Delegated Report		Analysis sheet		Expiry Date:	01/10/2020
		N/A		Consultation Expiry Date:	05/09/2020
Officer			Application Number(s)		
David Peres Da Costa			2020/2936/P		
Application Address			Drawing Numbers		
23 Ravenshaw Street London NW6 1NP			Refer to draft decision notice		
PO 3/4	Area Team Signature	C&UD	Authorised Officer Signature		
Proposal(s)					
Erection of a three storey plus basement building comprising 7 Class C3 flats (4 x 3-bed units and 3 x 2-bed units) with balconies at rear following the demolition of the existing house.					
Recommendation(s):		Refuse planning permission			
Application Type:		Full planning permission

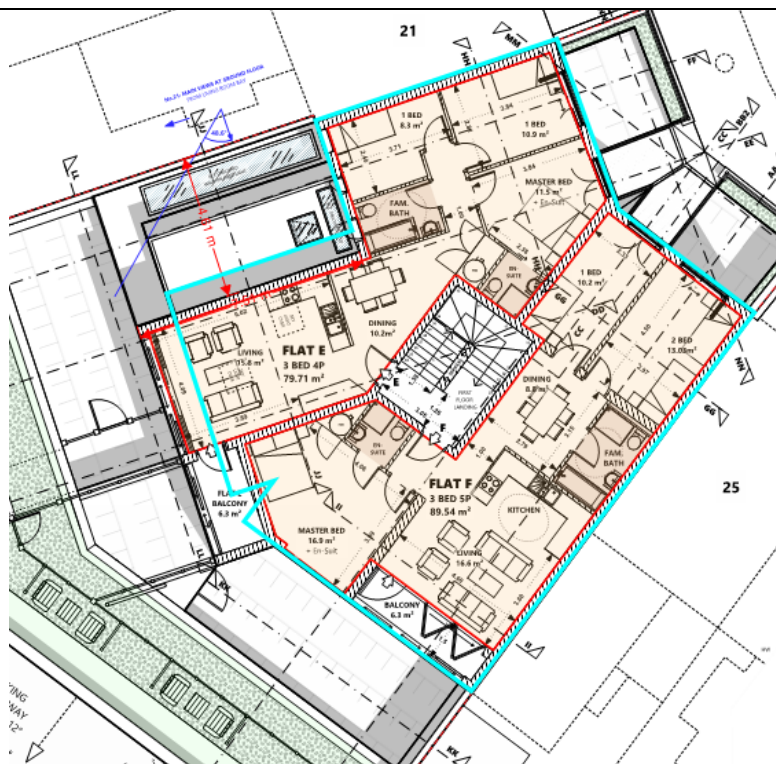
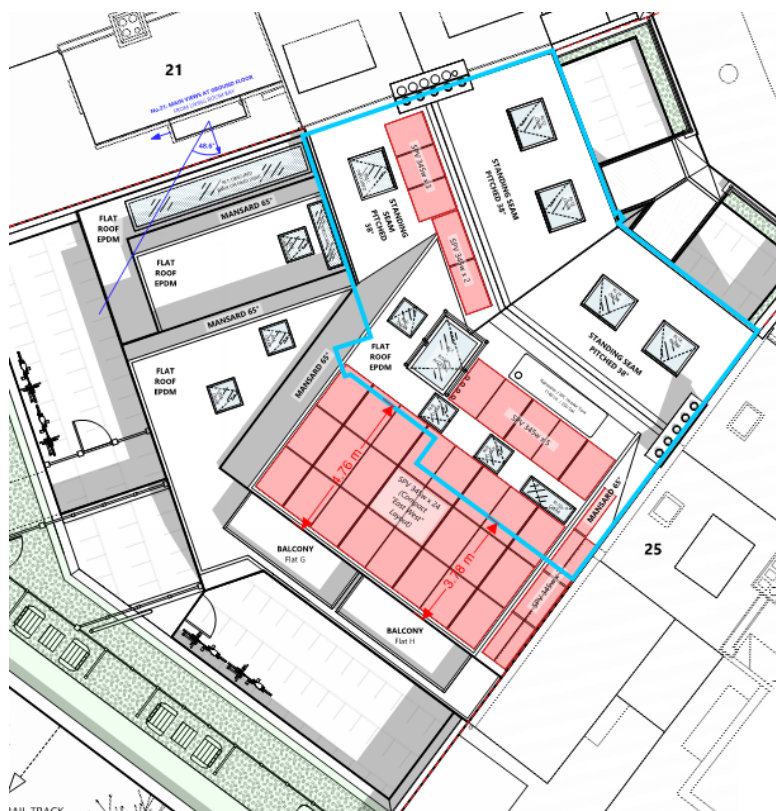
- 2.27. A comparison of the first floor of the appeal scheme and the current application demonstrates that the overall dimensions are very similar. The plan shown below is the appeal scheme with the outline of the current application laid over the top (as shown by the blue line)

- 2.28. A comparison of the second floor of the appeal scheme and the current application shows that the second floor of the current application has been significantly pulled back from the depth of the second floor sought at appeal. The plan shown below is the appeal scheme with the outline of the current application laid over the top (as shown by the blue line)

- 2.29. While the size of the second floor has been reduced, the design draws on oversized dormers in this street and neighbouring streets as a precedent. This results in the proposed southern dormers appearing disproportionately large.
- 2.30. The inspector for the previous appeal made the following observation:
- 2.31. *Regarding the proposed rear elevation to the property, the scale, mass and overall width and depth of the block would be excessive and significantly at odds with the surrounding*

pattern of development which is comprised of smaller rear terrace forms. Whilst the proposal would not exceed the height as the existing main houses in the terrace, the existing rear outrigger extensions are for the most part lower and therefore subservient in terms of height and width to each main house. I acknowledge that the proposed block would not extend beyond the depth of these outrigger extensions but the height and width of the block to this depth would appear disproportionately large and out of keeping with the rear of the terrace.

- 2.32. While the mass has been reduced at second floor level, the inspector's concerns in relation to scale, mass and overall width are still relevant. Officers consider that the rear of the development would still appear disproportionately large and out of keeping with the rear of the terrace. Although the scale and mass would not be visible from the streetscene, it would be apparent from the private realm of rear gardens in the street, and in private views from flats in Ellerton Tower on Mill Lane and from flats in the Brassey Road Estate to the south of the railway. It would also be visible from the railway line to the rear.
